UNITED STATES  
 NUCLEAR REGULATORY COMMISSION  
 REGION II  
 101 MARIETTA STREET, N.W.  
 ATLANTA, GEORGIA 30323

Report No.: 50-400/86-61

Facility Name: Harris 1

Inspection Conducted: July 28 - August 1 and August 11 - 15, 1986

### SHEARON HARRIS REFUELING CAVITY WATER SEAL DESIGN

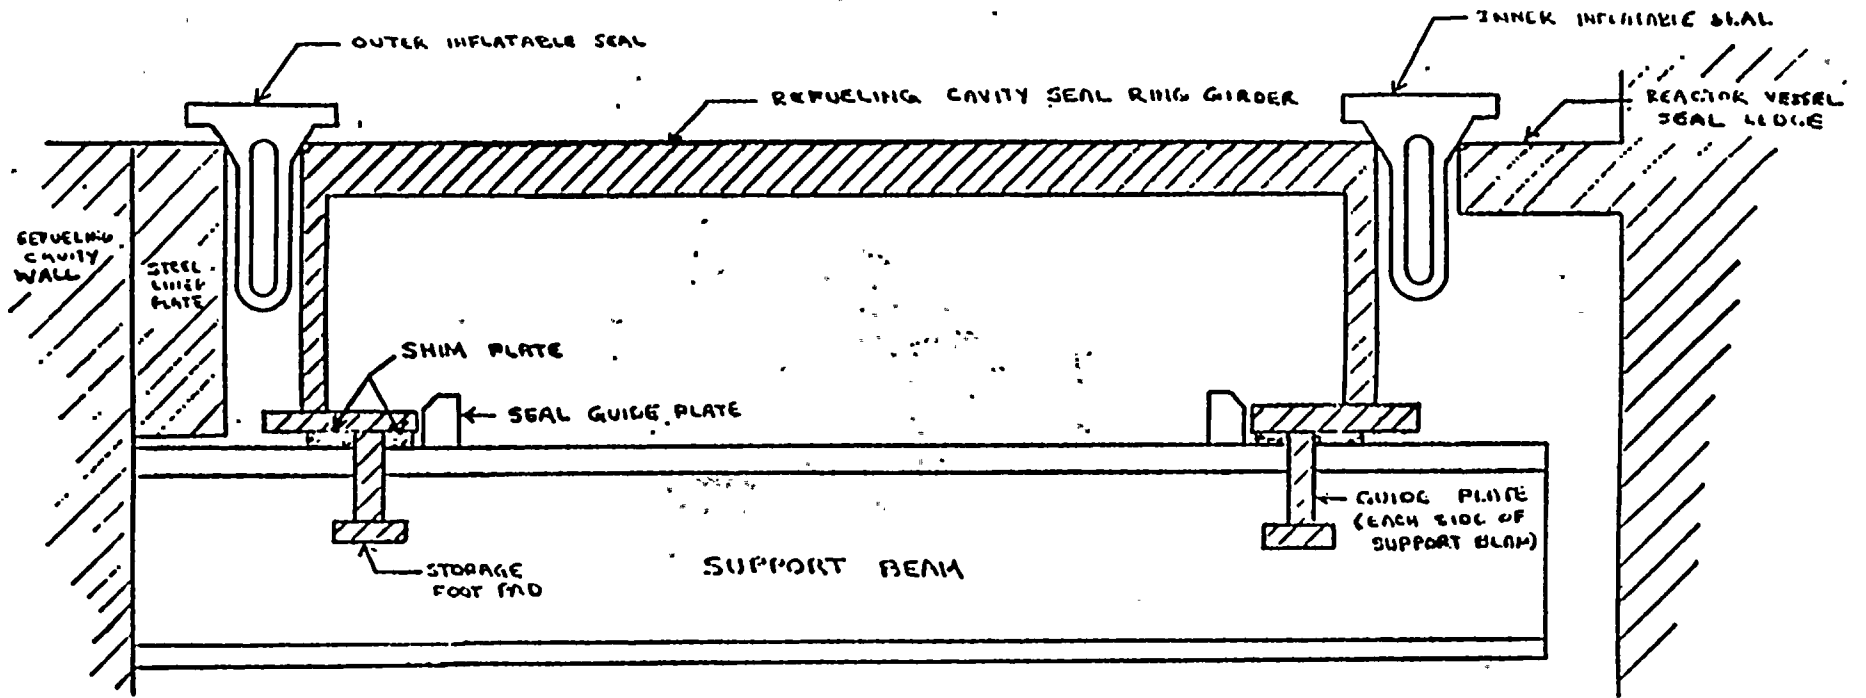
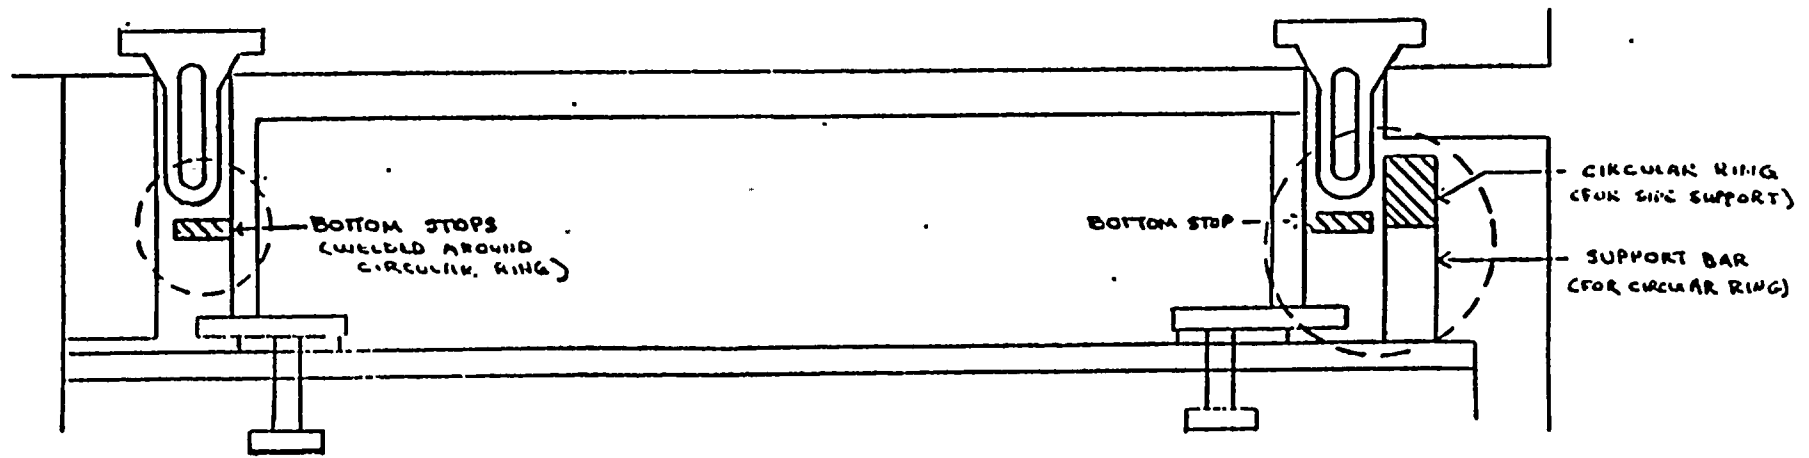
The cavity seal at Shearon Harris plant consists of two inflatable seals positioned on both side of the ring girder. The ring girder which is a circular metal plate structure resting on support beams that spans the open area between the reactor vessel refueling flange and the refueling cavity liner (Attachment 1). The ring girder structure is designed seismic Category 1. When the cavity seal is installed, the ring girder spans the majority of the three (3) feet eleven (11) inches opening, but leaves two inch nominal gaps on both sides for the pressurized inflatable seals.

An inflatable seal is installed in the nominal two inch gaps on both sides of the ring girder. When inflated, the lower portions of the seals expand to press tightly against the reactor vessel refueling ledge and ring girder on one side, and refueling cavity liner and ring girder on the other side to form the water-tight seal.

To further reduce the possibility of a seal failure incident, the design has been modified to prevent the inflatable seal from pushing through the cavity gap as follows:

- 1) Metal plates have been welded around the side of the ring girder below the location of the inflatable seals and will act as "bottom stops" for the seals to prevent slippage down through the gap.
- 2) A circular metal ring welded to support bars which are attached to the cavity seal support beam provides additional surface for the inflatable seal to press against.

- The design/installation of the cavity seal as indicated in the response, dated July 1, 1985, does not adequately describe how the two inflatable seals are positioned on the side of the ring girder.
- The response states that the primary source of make-up water is from the Refueling Water Storage Tank (RWST) using the fuel pool cooling pumps or the fuel pool clean pump. This is not consistent with AOP-031 which requires the use of RHR pumps.
- There are no provisions in the procedure GP-009 to test the refueling cavity seal for leakage after the cavity is flood.

During the exit meeting on August 15, 1986, licensee management committed to provide a supplemental response to IEB 84-03 to correct the above discrepancies.
